UNITED STATES PATENT AND TRADEMARK OFFICE

APPLICATION NO.	FILING DATE	FIRST NAMED INVENTOR	ATTORNEY DOCKET NO.	CONFIRMATION NO.
10/695,178	10/28/2003	J. Daniel Raulerson	MED0065	4287
33941	7590	05/18/2009	EXAMINER	
Fox Rothschild LLP Blue Bell 2000 Market Street Tenth Floor Philadelphia, PA 19103			VU, QUYNH-NHU HOANG	
			ART UNIT	PAPER NUMBER
			3763	
			MAIL DATE	DELIVERY MODE
			05/18/2009	PAPER

DETAILED ACTION

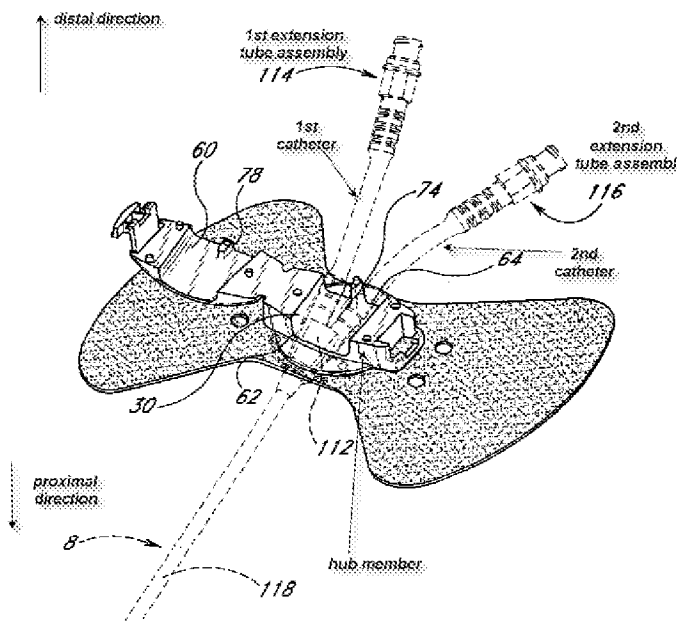
Bierman discloses a multiple catheter assembly comprising: a first catheter; a second catheter; a first and second extension tube 114, 116; a hub member 20 adapted to be releasably attachable to and around the first and second proximal end.

It has been held that the recitation that the hub member is "adapted to/capable of" performing a function is not a positive limitation but only requires the ability to so perform. It does not constitute a limitation in any patentable sense. In re Hutchison, 69 USPQ 138.

Additionally, it is well established that a recitation with respect to the manner in which an apparatus is intended to be employed, i.e. after catheter implantation and subcutaneous tunneling... to respective medical devices, a functional limitation, does not impose any structural limitation upon the claimed apparatus which differentiates it from a prior art reference disclosing the structural limitations of the claim, see In re Pearson, 494 F.2d 1399, 181 USPQ 641 (CCPA 1974).
